Groundwater Application Review Summary Form

Application # G- 19245

PUBLIC INTEREST REVIEW FOR GROUNDWATER APPLICATIONS

TO: Water Rights Section Date 11/16/2023
 FROM: Groundwater Section Joe Kemper
Reviewer's Name
 SUBJECT: Application G- 19245 Supersedes review of NA
Date of Review(s)

Well Location Map

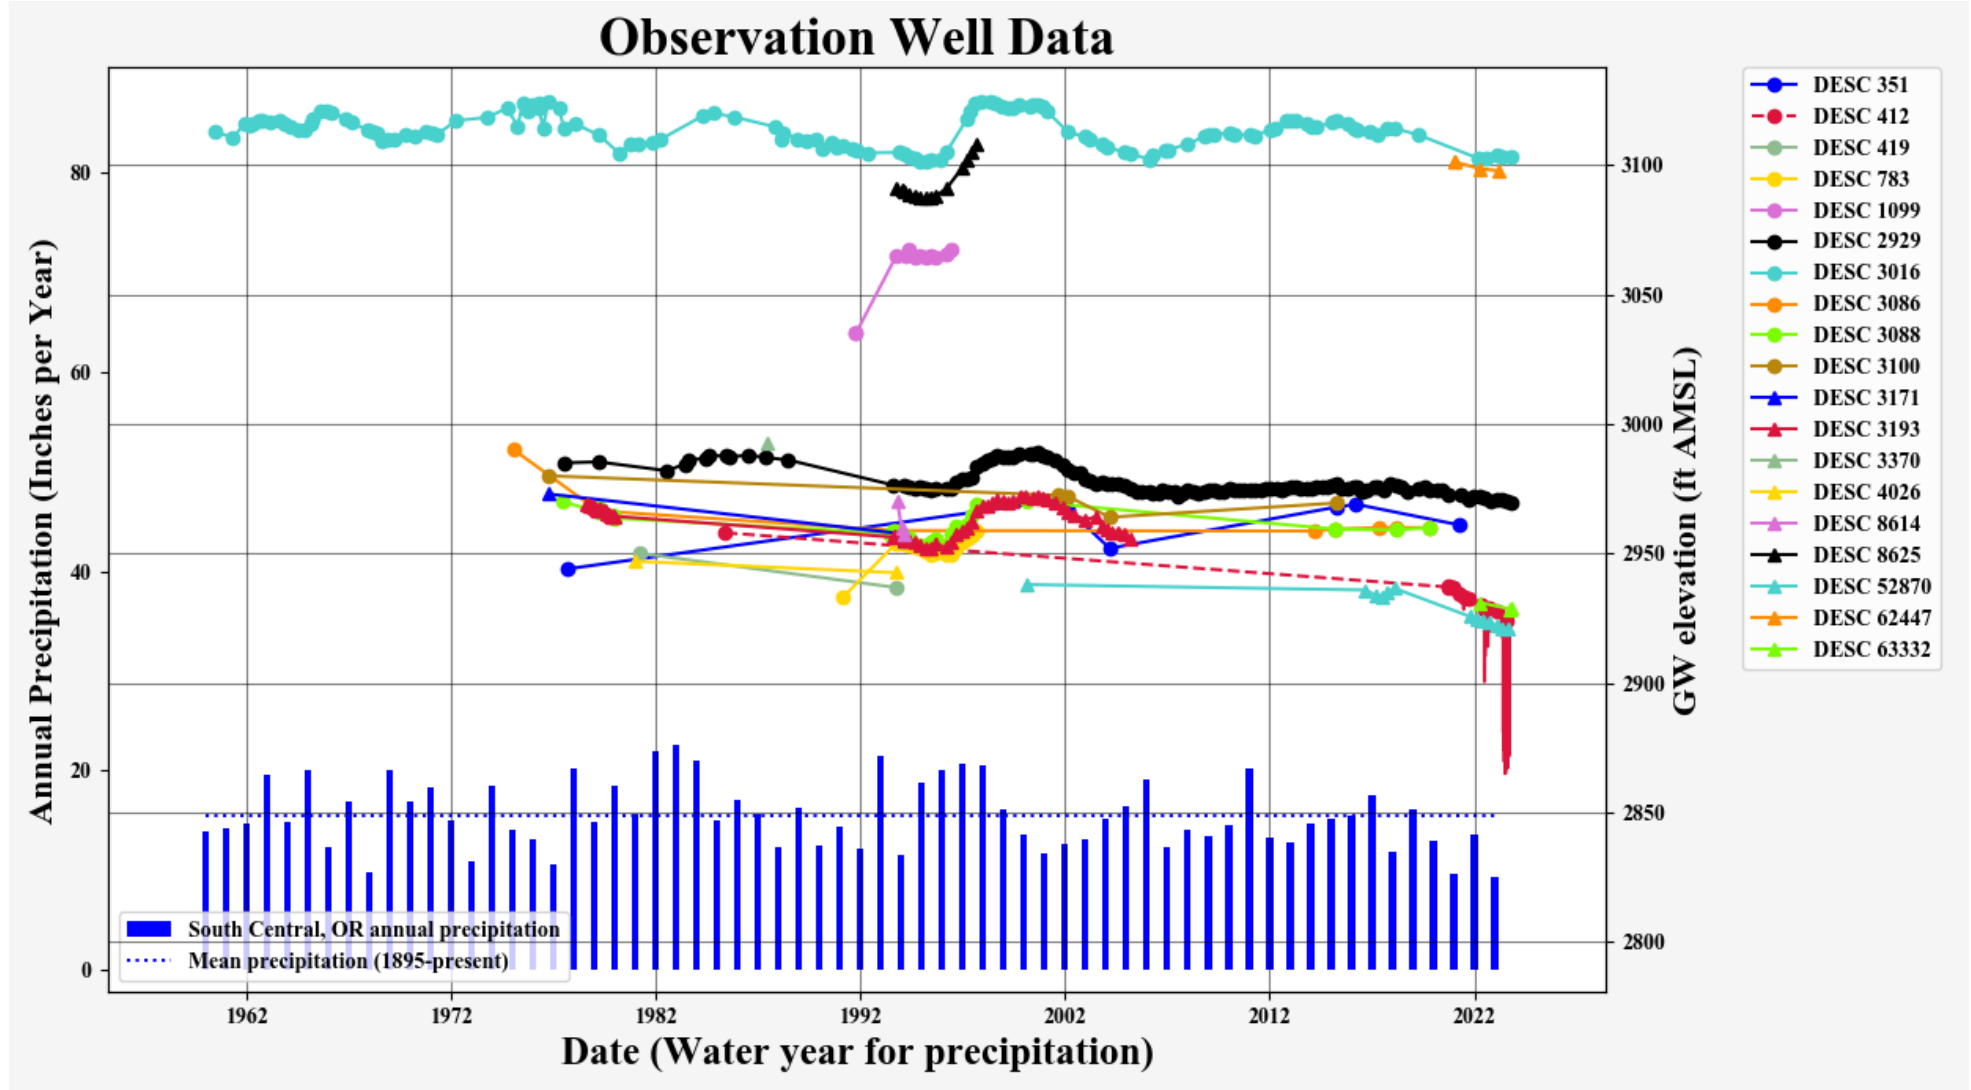
The reference level for DESC 3370 shall be 256 feet BLS, which corresponds to the driller’s measurement taken after well construction. This is the only known water level for the applicant’s well. However, adjacent wells in the target aquifer share very similar trends and elevations, and there are multiple long-term observation wells in the area. Water levels in DESC 3193 and DESC 2929 show a natural dynamic range of 15-20 feet. Measurements at DESC 2929 indicate that the aquifer was at or near a natural high point when DESC 3370 was drilled. Water levels in the target aquifer typically show very little seasonal fluctuation, so the time of year when the driller’s measurement was taken is acceptable.
